Access Compliance Report

Public Rights-of-Way

(Curb Ramps)

Intersection ID: N/A	Main Street: ASCENSION_WY	Cross Street: BROOKSVALE_ST	Location: NE
ADA ID: D8CFD326FF1E	Ramp Type: Perp	Initial Pass/Fail: Fail	Overall Compliance: No
Severity Score: 13.75			
Codes/Mitigation Info/Possible Solution		Field Measurements/Component Compliance

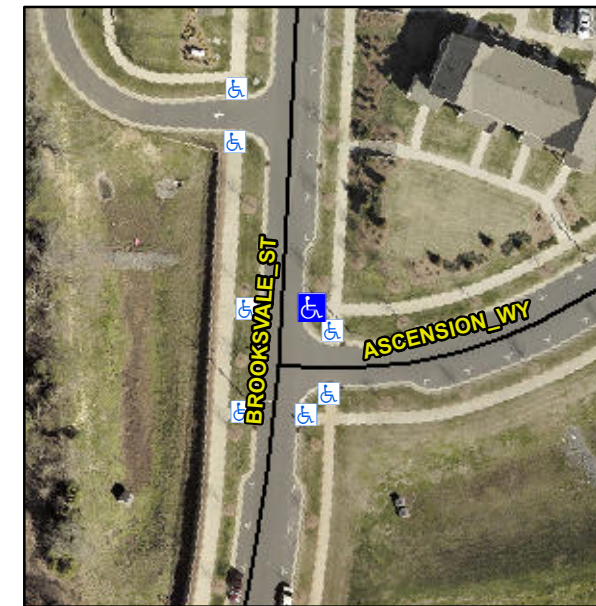
R304.2.2, R304.5.3

Compliance	Description	Data	Compliance	Description	Data
N/A	Ramp Length (in)	72.0	No	Ramp Slope (%)	9.6
Yes	Ramp Width (in)	70.5	No	Ramp XSlope (%)	2.2
N/A	Flare Type LT	N/A	N/A	Flare Type RT	N/A
N/A	Flare Slope LT (%)	N/A	N/A	Flare Slope RT (%)	N/A
N/A	Flare Traversable LT?	N/A	N/A	Flare Traversable RT?	N/A
N/A	Landing Length (in)	N/A	N/A	DWS Provided?	N/A
N/A	Landing Width (in)	N/A	N/A	DWS Contrast?	N/A
N/A	Landing Slope (%)	N/A	N/A	DWS Length (in)	N/A
N/A	Landing X Slope (%)	N/A	N/A	DWS Full Width?	N/A
N/A	Landing Curb? (Y/N)	N/A	N/A	DWS Offset (in)	N/A
N/A	Shared Landing?	N/A			
N/A	Gutter Ponding?	N/A	N/A	Gutter Slope (%)	N/A
N/A	Gutter Lip Ht (in)	N/A	N/A	Gutter X Slope (%)	N/A
N/A	Painted X Walk1?	No	N/A	Painted X Walk2?	N/A
	X Walk 1 Direction	To W		X Walk 2 Direction	N/A
N/A	X Walk 1 Width (in)	N/A	N/A	X Walk 2 Width (in)	N/A
	X Walk 1 Slope (%)	2.2		X Walk 2 Slope (%)	N/A
	X Walk 1 X Slope (%)	1.2		X Walk 2 X Slope (%)	N/A

Remove & Replace Entire Ramp.
